From: [REDACTED]
To: [REDACTED]
CC: [REDACTED]
Sent: 2/24/2021 7:41:31 AM
Subject: RE: O8W-PM 35217268, 35224712, 35224713 - Bucks Creek 1101 Phase 1,2&3 - Pre-Engineering Meeting

Bucks Creek 1101- PM# 35217268

Subject: O8W-PM 35217268, 35224712, 35224713 - Bucks Creek 1101 Phase 1,2&3 - Pre-Engineering Meeting

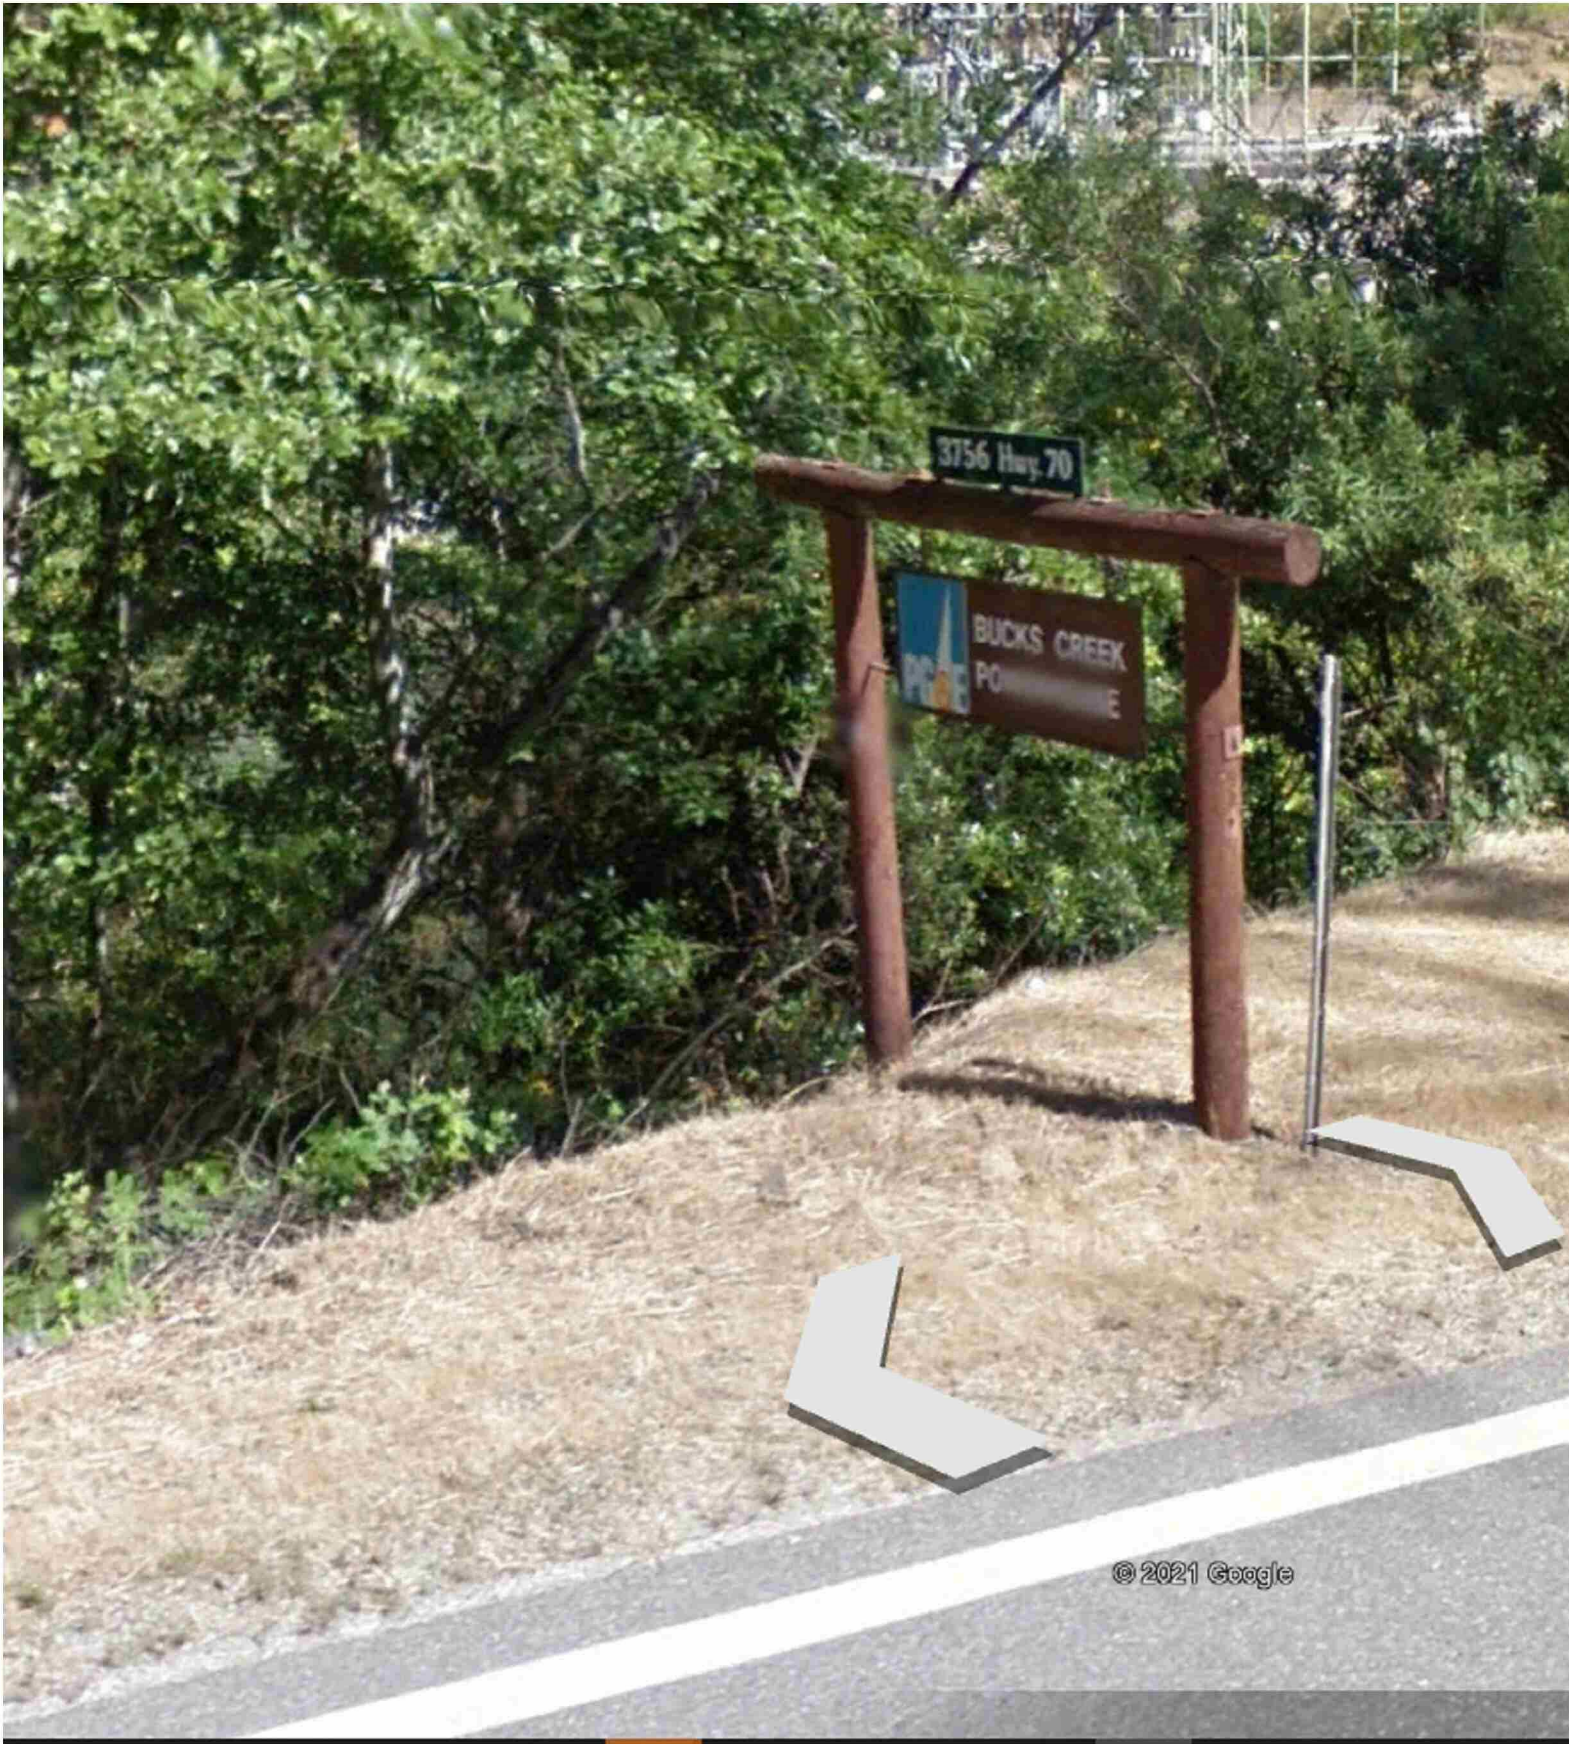
Attached are the 'base-map' limits in a kmz. file. As you will see, we need our base-map to go about ~100' into the tunnel at the south end (see pedestal in picture below....please begin about ~50 beyond this point which is about ~100' beyond the Cresta Dam).
